AGENDA
FARRAGUT MUNICIPAL PLANNING COMMISSION

January 19, 2017
7:00 p.m. Farragut Town Hall

Preliminary Subdivision Plat - Lot Layout
Easton Park
11739 Turkey Creek Road
Farragut, Tennessee
HFTC Partnership, GP

Preliminary Plat - Site Grading and Drainage Plan
N. Peterson Road Extension
Town of Farragut
N. Peterson Road
Farragut, Tennessee
JAN 10 2017

C1.1
SHEET 3 OF 18

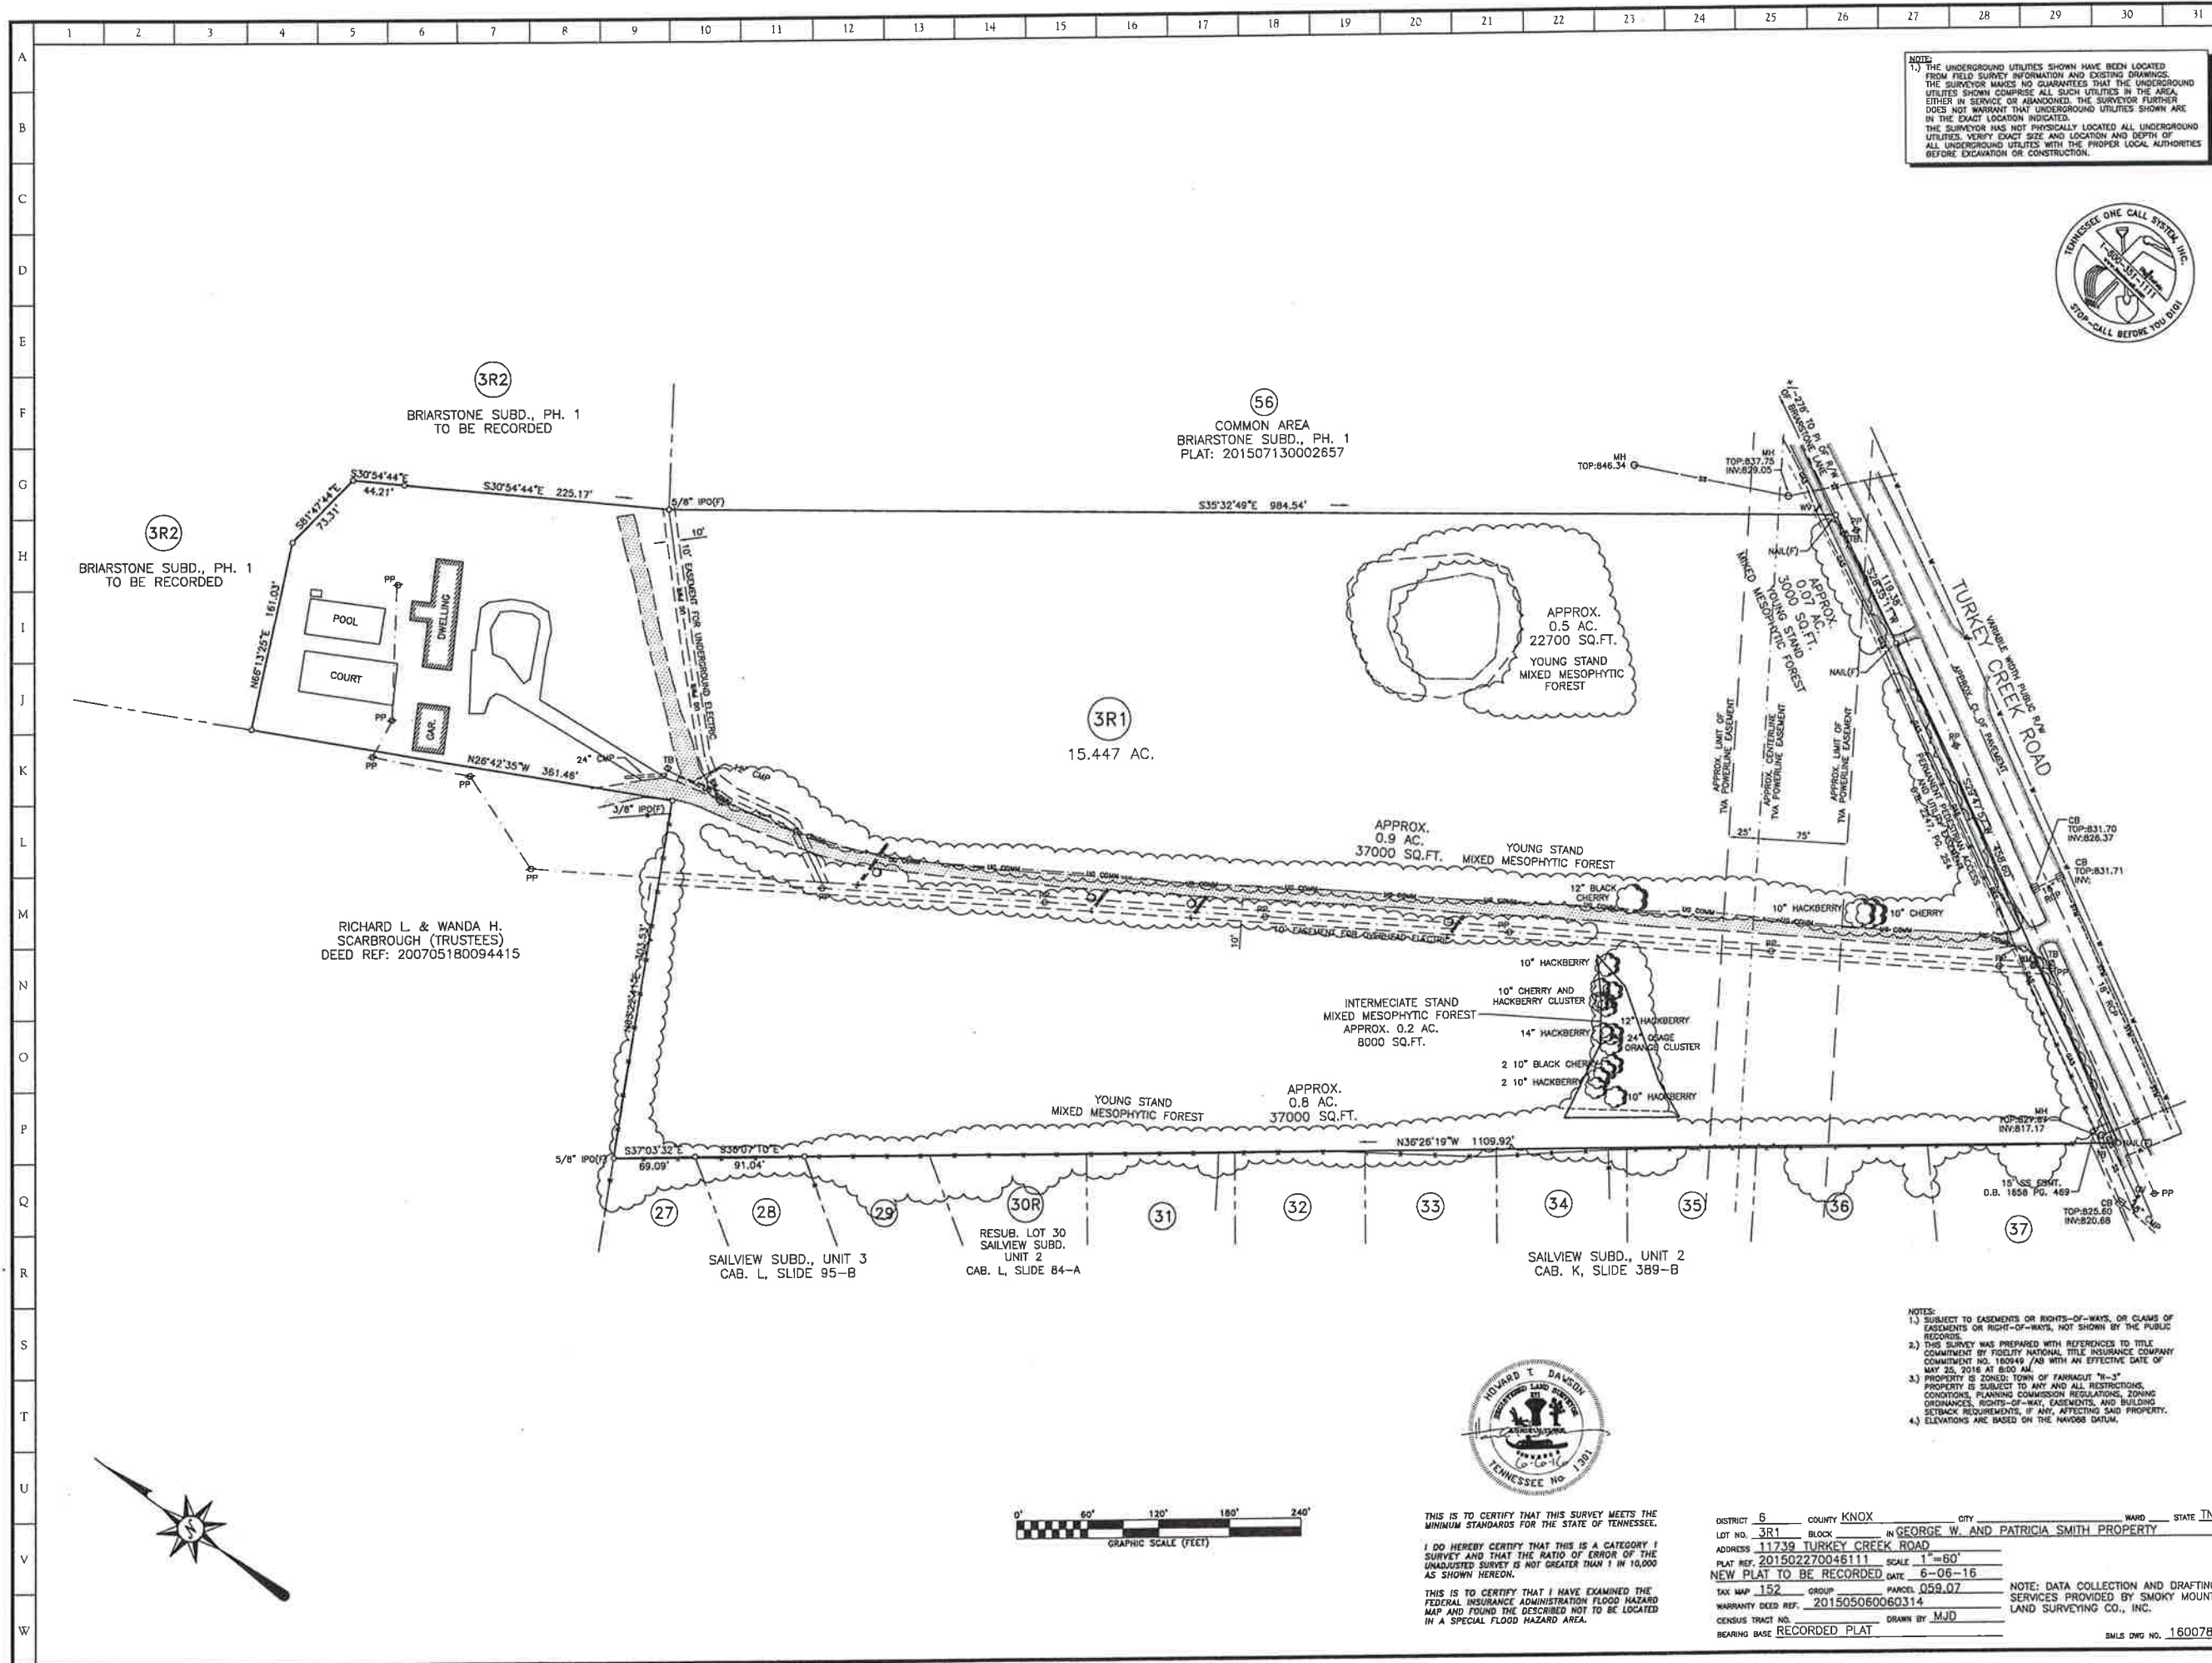
- 3) On the cover sheet please provide an address and a tax map and parcel reference;
 - a. Information added to the cover.
- 4) Please provide the correct acreage of the property involved in this subdivision;
 - a. Sheet C1.1 has been revised with corrected information.
- 5) On the cover sheet please provide the name, address, telephone number, e-mail of the owner and developer;
 - a. **Information has been added to the Cover Sheet.**
- 6) On Sheet C-1, please include the updated property lines, zoning designations, map and parcel information, and acreages;
 - a. **Information has been updated.**
- 7) The staff assumes that the closed contours is a farm pond and not a sinkhole. Please verify;
 - a. **Please see attached letter.**

- a. **Note has been added to sheet C1.1.**
- 17) Please show the zoning lines and the zoning of abutting properties;
- a. **See sheet C1.1.**
- 18) Is the width of Lots 14, 18, 23, and 27 buildable?

C4.1
SHEET 12 OF 18

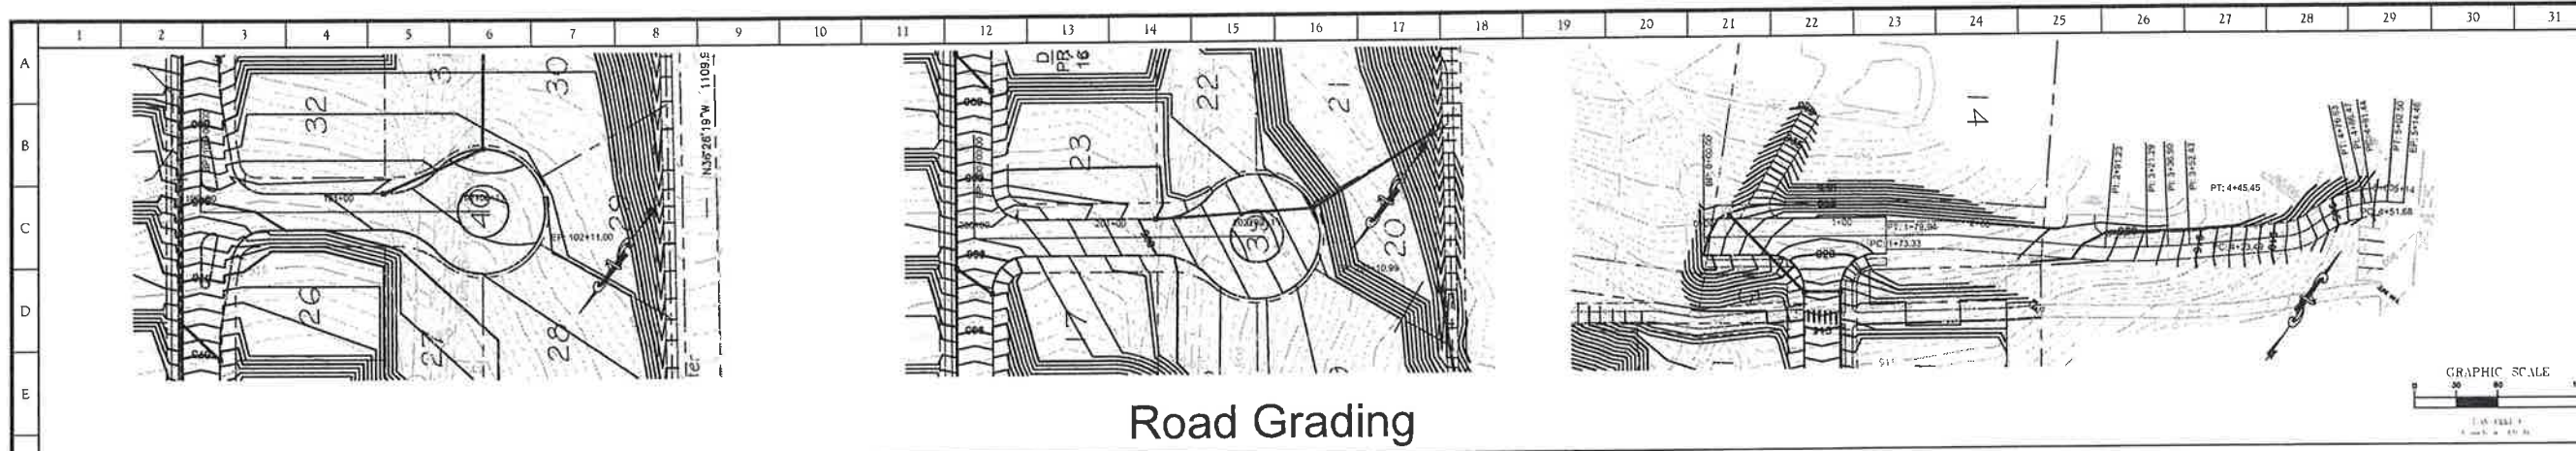
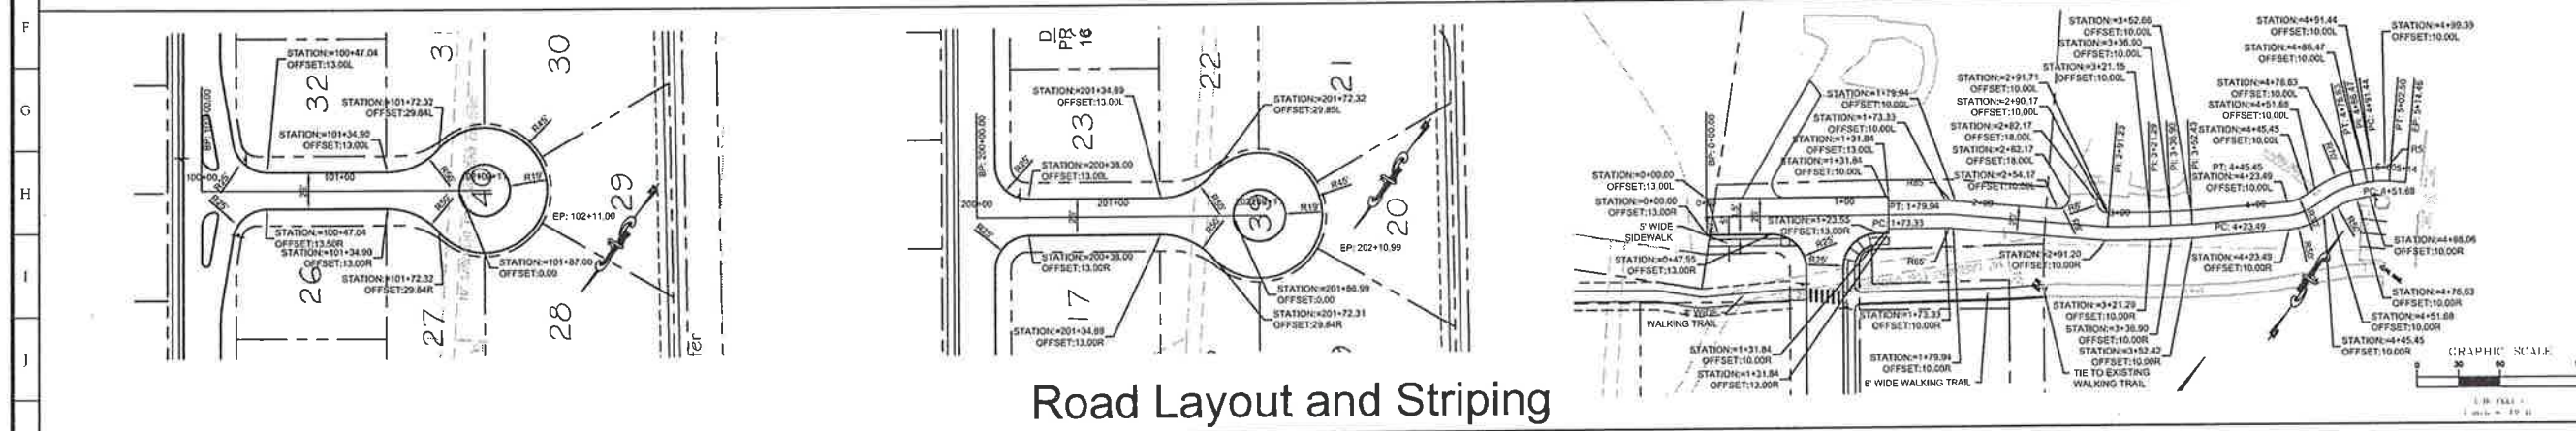
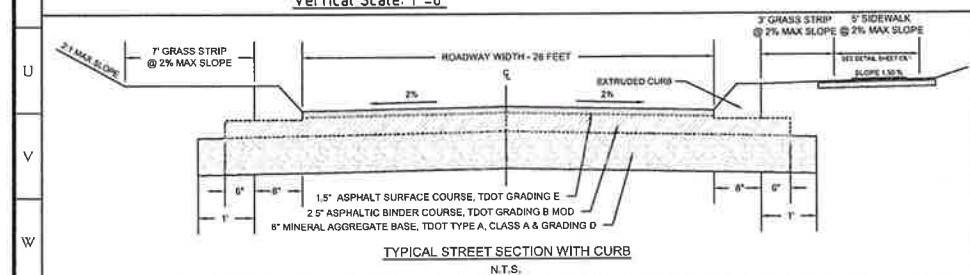
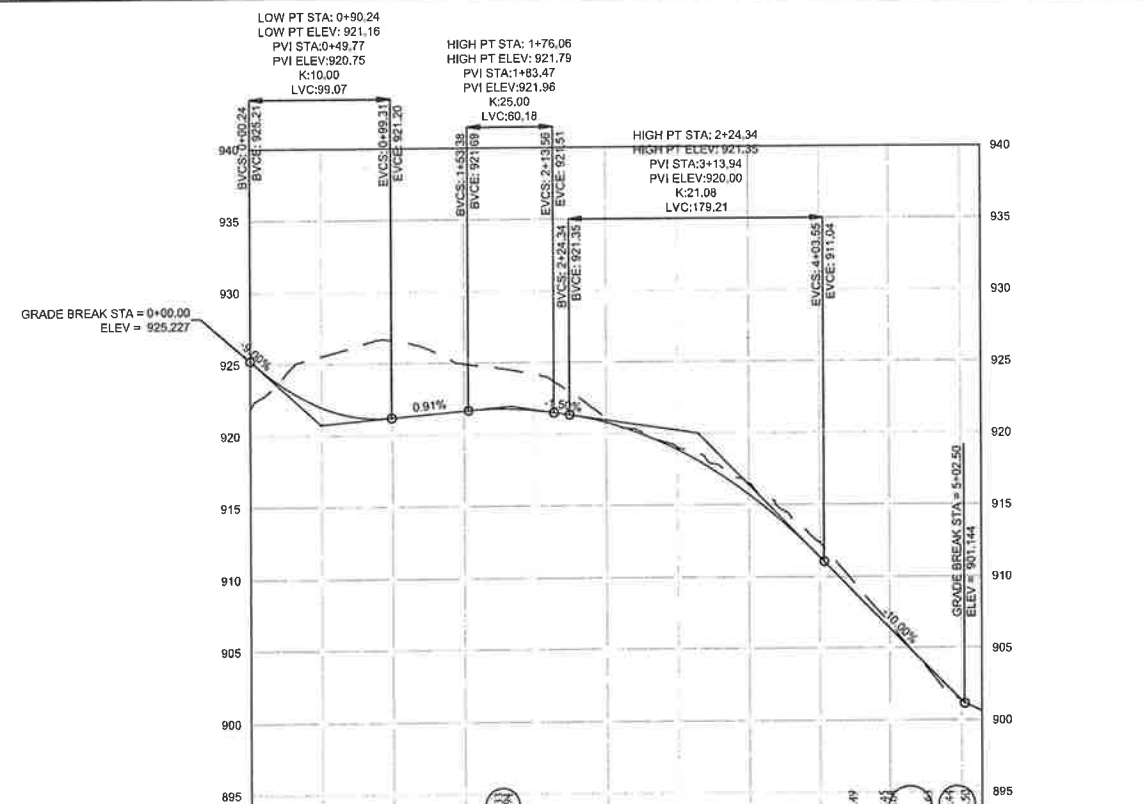
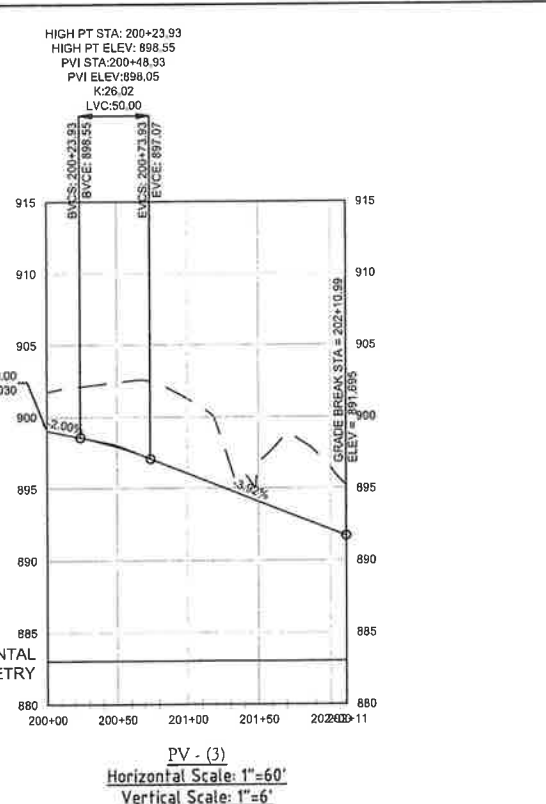
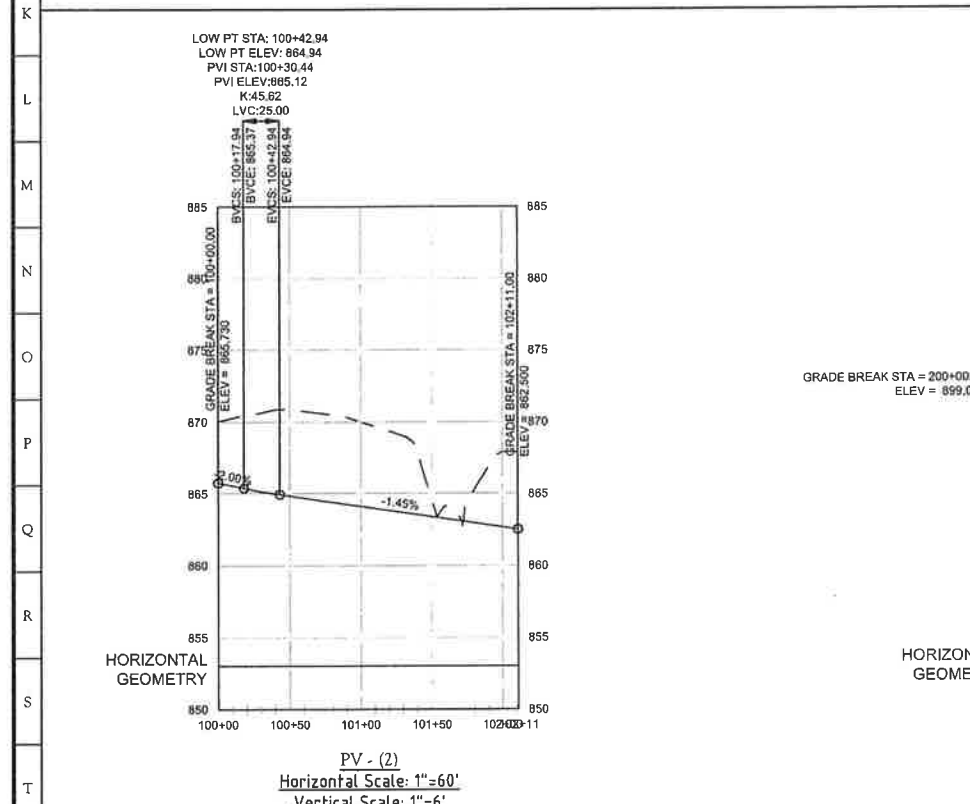
- 1) Provide note on sheet 5.0 stating that "All fire hydrants will provide the required 1000 gpm at 20psi";
 - a. **Note added to Sheet C5.0.**
- 2) Provide a grade detail for the approach at the fire apparatus access road intersection with Briarstone Lane;
 - a. **See sheet C4.1 for road profile.**

- a. **See sheet C4.1 for road profile.**
- 14) If the secondary access cannot be provided please reduce the number of lots to 30 or less or sprinkle the buildings;
